# **OXFORDSHIRE COUNTY COUNCIL'S RESPONSE TO CONSULTATION ON THE FOLLOWING DEVELOPMENT PROPOSAL**

**Application no:** P14/V2873/O-3

**Proposal:** Outline planning application for a residential development of up to 4,254 dwellings, mixed-use local centres, primary schools, sports pitches, community and leisure facilities, special needs school, open space and extensive green infrastructure, hard and soft landscaping, attenuation areas, diversions to public rights of way, pedestrian and vehicular access and associated works.(as amended by drawings and information accompanying letter from Agent dated 10 March 2016)

**Location:** Land to the West of Great Western Park (Valley Park) Didcot (in the parishes of Harwell and Milton)

#### Five arm roundabout

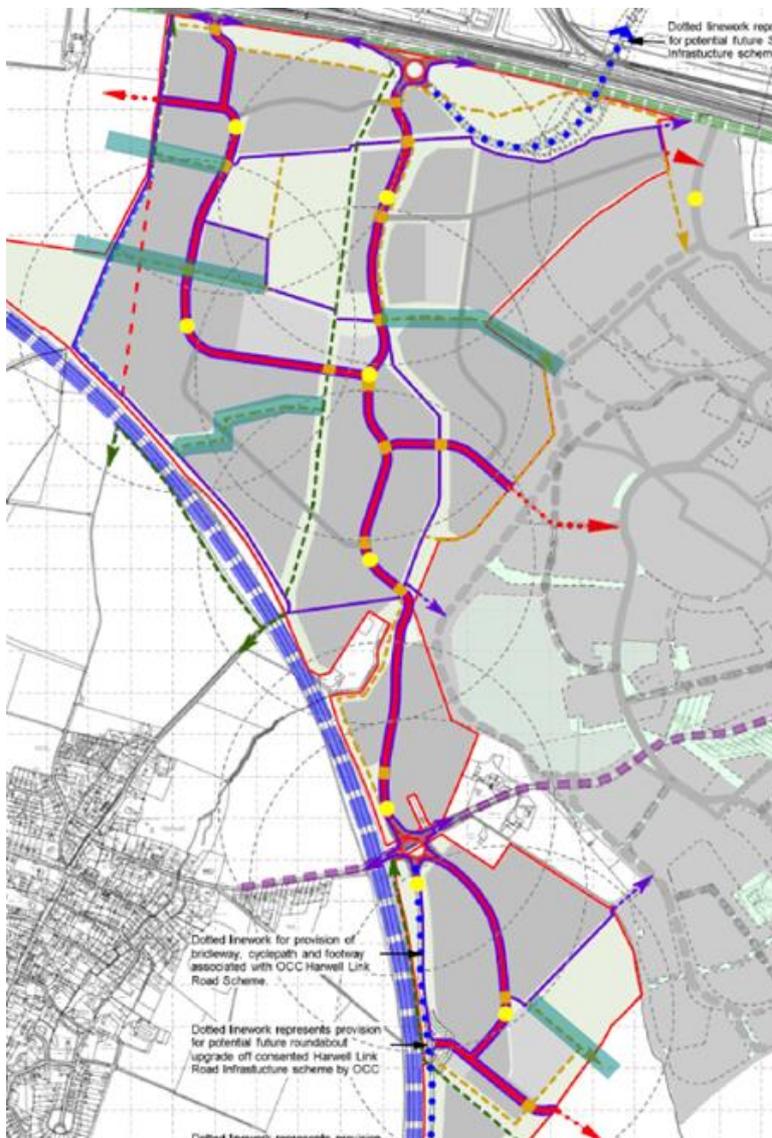
A 5arm roundabout is proposed on the B4493, spine road, HLR and a new road into the southern part of the development. Concerns have been raised previously as to safety and convenience of this arrangement for pedestrian and especially users of the bridleway. Following a road safety audit an amended scheme has been proposed and subject to the provision of a controlled pegasis type crossing to both the Southern and Northern Site Access Roads, to be shown on plan 10219-HL-61, is considered appropriate. This amended plan shall be submitted prior to planning committee.

The final design should allow for the B4493 to be a strategic cycling route in line with the County's Science Vale Cycling Strategy. Drawing number 10219-HL-61 shall be amended to show controlled pedestrian crossing point on Southern Access Arm.

## **Public Transport**

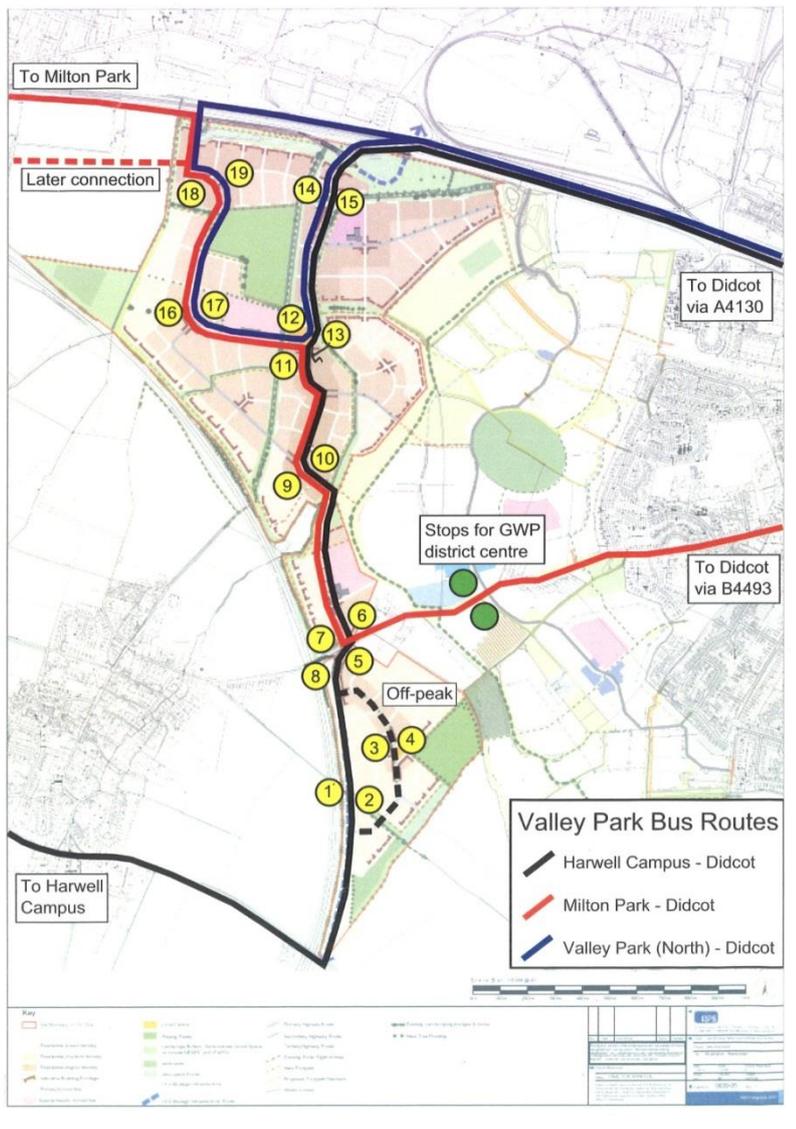
There is recognition in the Vision contained in the Design and Access Statement of the intention to make the development attractive for long term viable bus routes as follows: 'Public transport will help to create a sustainable, connected and accessible neighbourhood, with extensive opportunities for public transport operators to run viable bus routes through the site. The main internal strategic route has provision for a high frequency bus route running between the A4130 and A417, and will utilise the proposed Harwell Strategic Link Road through the south of the site. Equally important is the provision of opportunities for east-west movement between Great Western Park/Didcot town and North West Valley Park. The highest density development will be along the bus routes, ensuring the largest number of people can access these services, and also assisting with their viability.'

There is some inconsistency later with some drawings (e.g. the Proposed Bus Connections Plan) not showing a bus route through the Harwell Link Road. We consider that utilisation of the spine road and the HLR will ensure the most direct and fastest bus route between Didcot and Harwell Campus and therefore envisage its use. The following is a map of possible bus routes advised in our May 2015 comment:
